Office Action Summary

09/768885

Moreland et al

I. Claims 1-12, drawn to an electrically heated deicer panel, classified in Class 219, subclass 202.

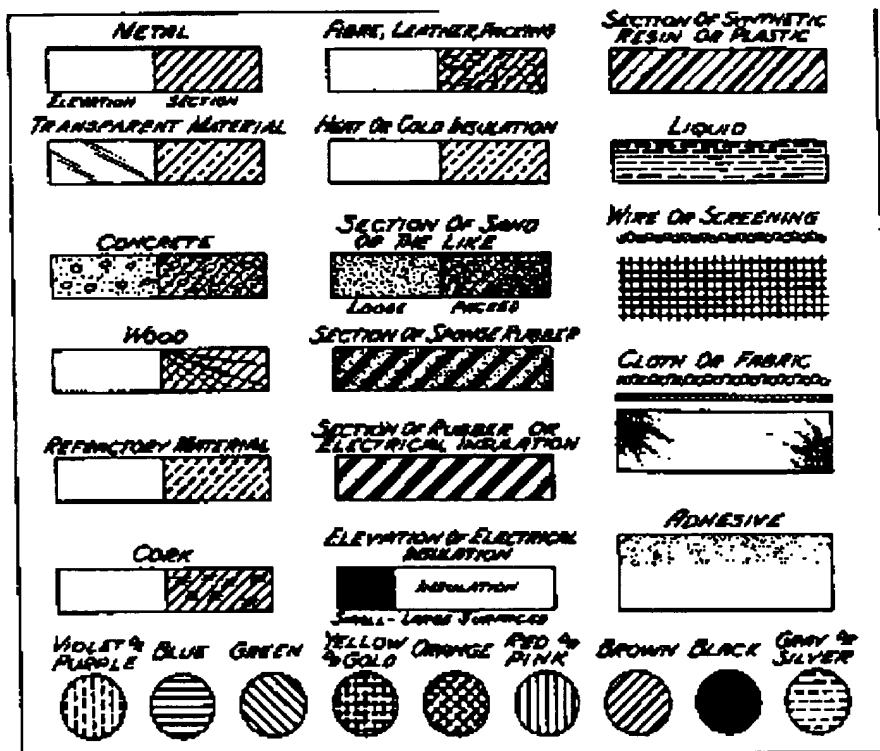
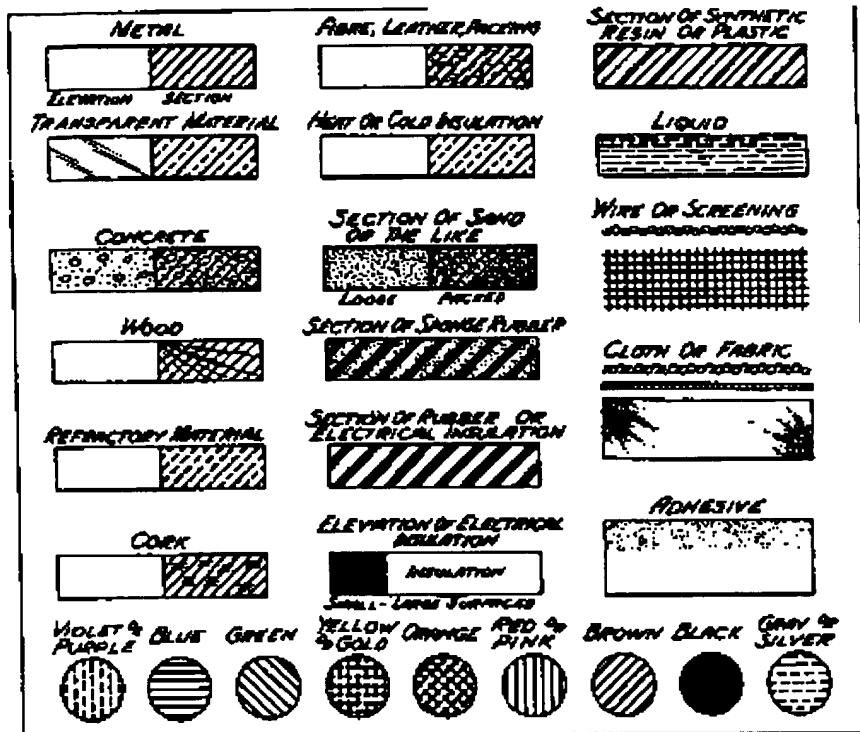
The drawings are objected to because of the following informalities:

An **additional cross sectional figure** is needed showing each layer of the finished deicer with proper cross sectional hatching for clarity. Proper cross-sectional hatching is required to properly denote appropriate materials in accordance with MPEP 608.02 (see the drawing below for proper hatching examples).

The response to this action must include a separate letter addressed to the examiner and contain: (1) sketches showing *in red* the drawing changes required above and (2) a request that the examiner approve the changes as shown on the sketches.
